APPLICATION FOR PERCOLATION TEST

SUBJECT: APT #7015 (J. F. Hodges)
Lot No. 24-B, Middle Stream Road
Rolling Acres Subdivision
10-18-73

SITE DISAPPROVAL REPORT
INDIVIDUAL SEPTIC TANK SYSTEM WITH SUBSURFACE, SOIL ABSORPTION, EFFLUENT DISCHARGE

SOIL INVESTIGATION REPORT

DIAGRAM OF PROPERTY

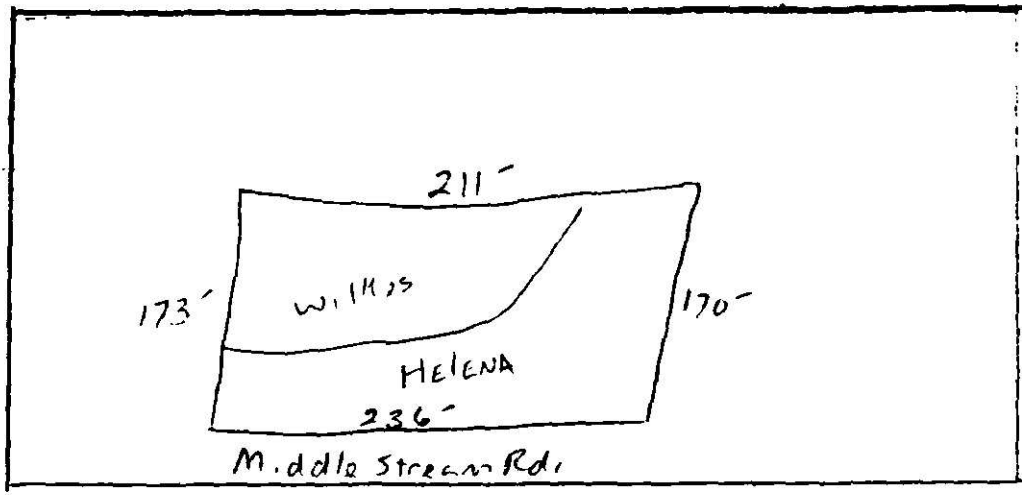
Recommendations Based on this investigation, the lot is not recommended for approval for installation of a septic tank system.

See diagram on back
